ARCHETEXTURAL ADDENDUM # 1

MECHANICAL ADDENDUM # 1

Job Title: FREEZER RENOVATION

Client: NATIONAL RESEARCH COUNCIL

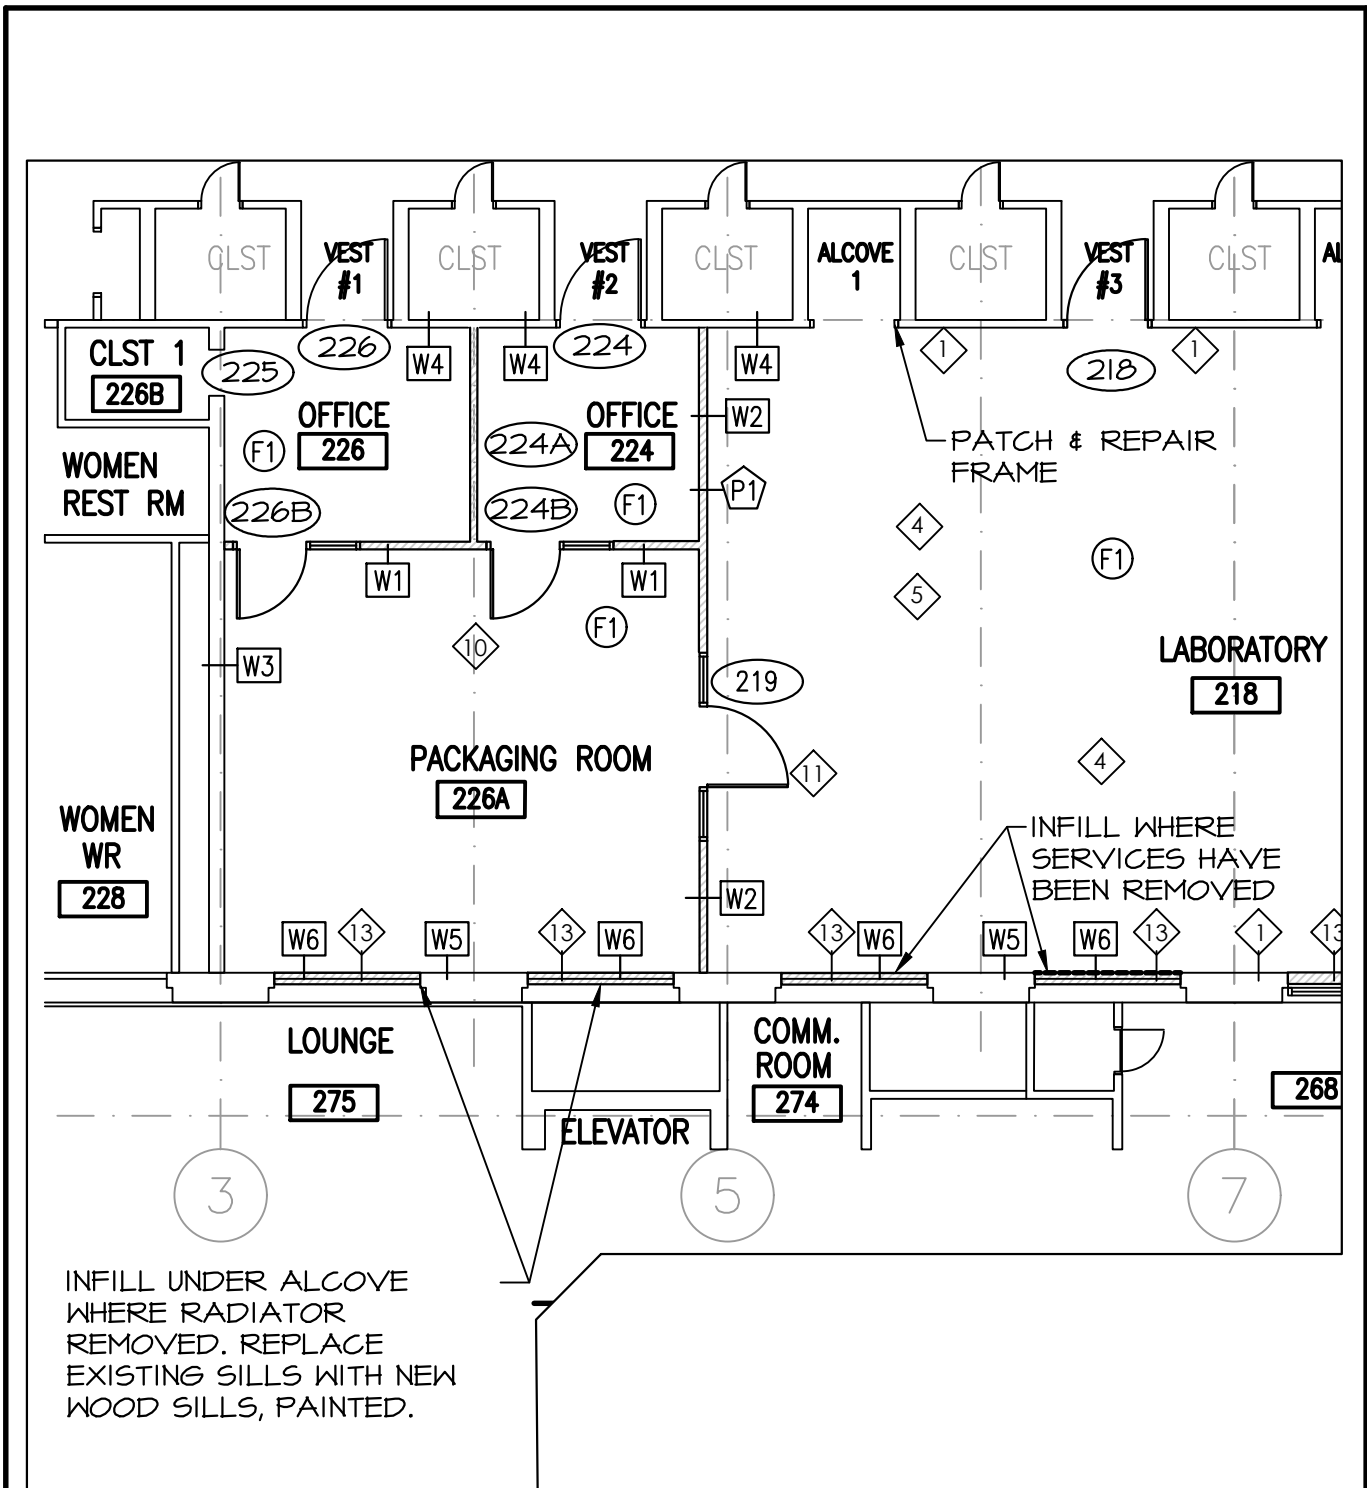
2. Door 226B has changed from an RHR to an LHR as indicated on ASK-01 attached.
3. The existing metal door frame in the opening to Alcove #1 shall remain, sharp edge cut outs which remain from when hardware was removed to be infilled with new metal plate and patched prior to painting. See new note on ASK-01.

Dwg. No.
MSK1-M-101

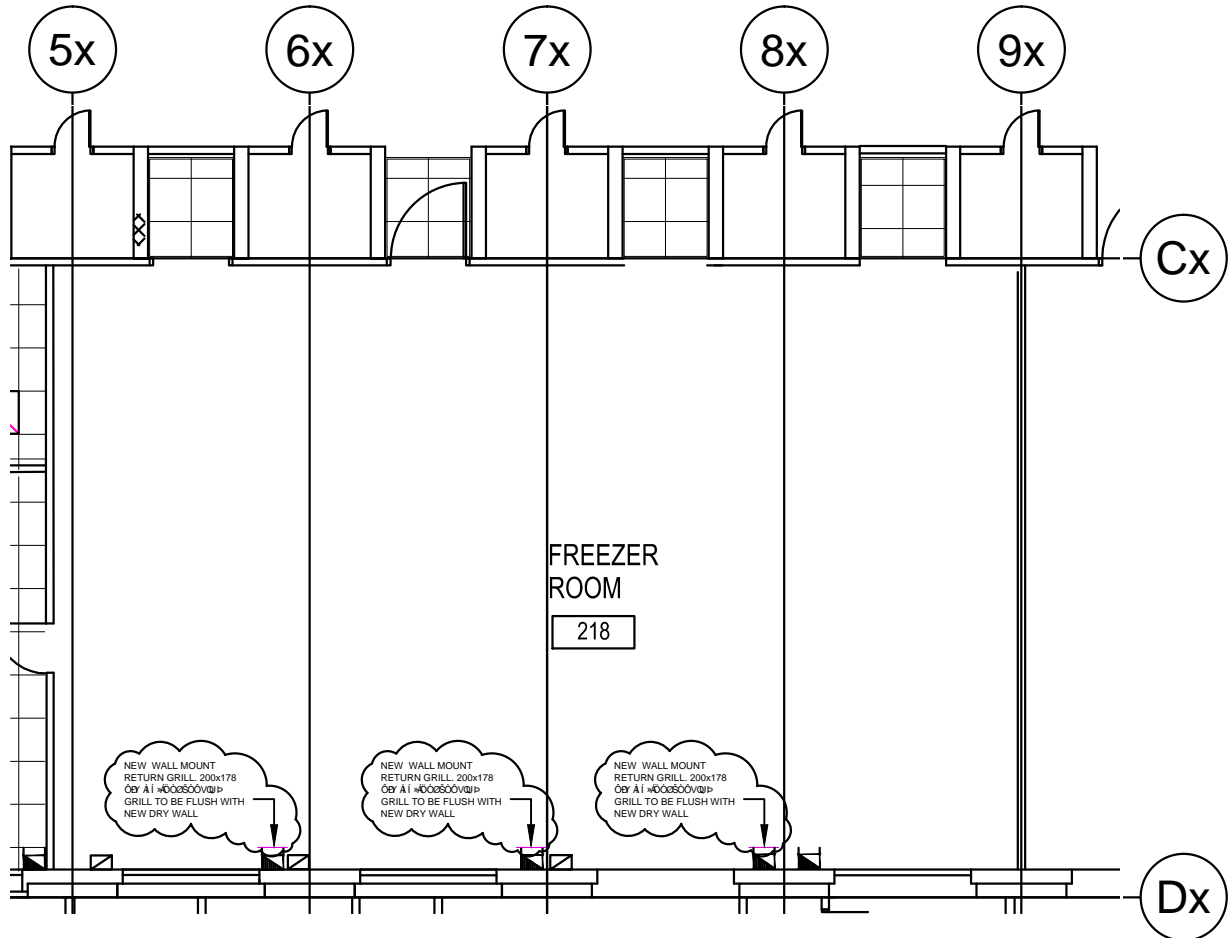
Reference Dwg. MSK-1-M-101:

Add return grills as indicated on MSK-1-M-101 and “DIFFUSER / GRILLE SCHEDULE” Designation R3.

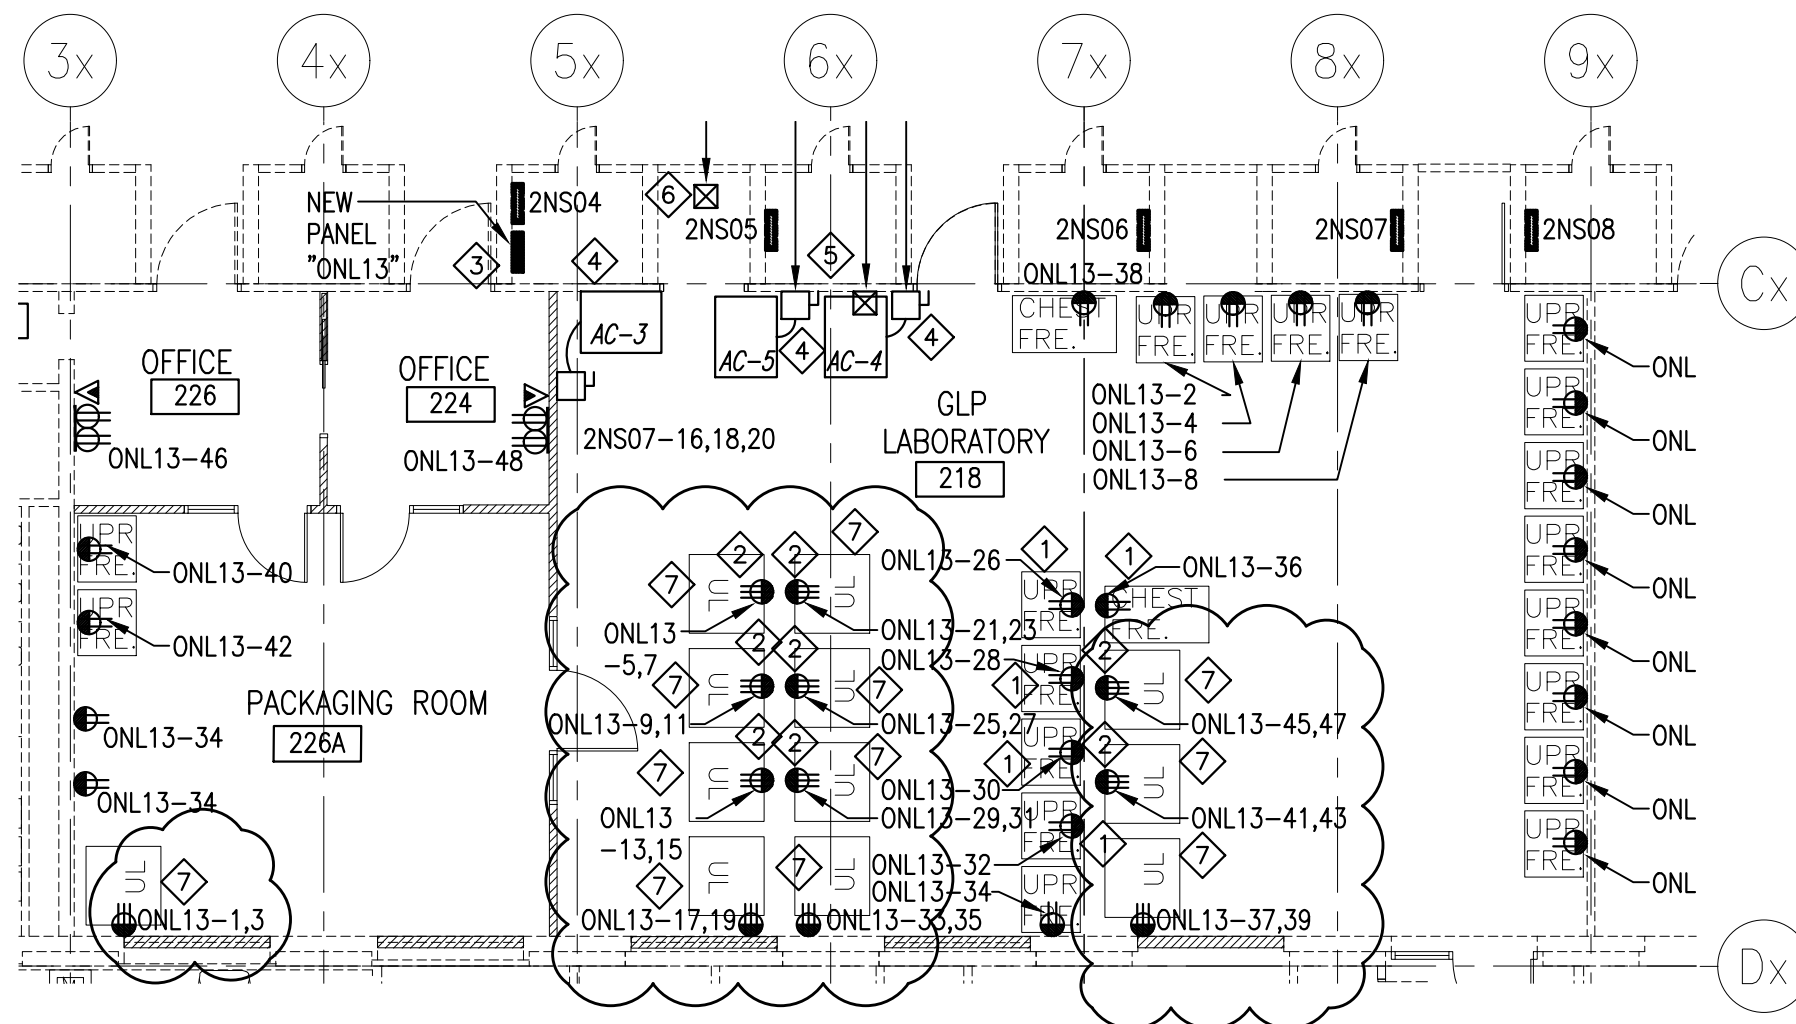
Reference Dwg. ESK-E-103.1:

Add new Siemens communications alarm loop through the new Ultra-Low freezers as shown on ESK-E-103.1 and Electrical Note 7.

NOTE 7: EACH CONVIRON ULTRA-LOW UNIT IN FREEZER ROOM (TOTAL OF 12) TO BE MONITORED FOR ALARM, RUN A 2C/#20AWG CABLE EXISTING CONTROL PANEL DPU#5 ON FLOOR ABOVE TO EACH ULTRA-LOW UNIT IN SERIES (LOOP). PROVIDE A 27mm CONDUIT RACEWAY FROM PANEL DPU#5 TO FREEZER ROOM FOR CABLING AND TERMINATE AT A JUNCTION BOX AT EACH UNIT, FINAL CONNECTION TO USE 16mm FLEXIBLE CONDUIT.
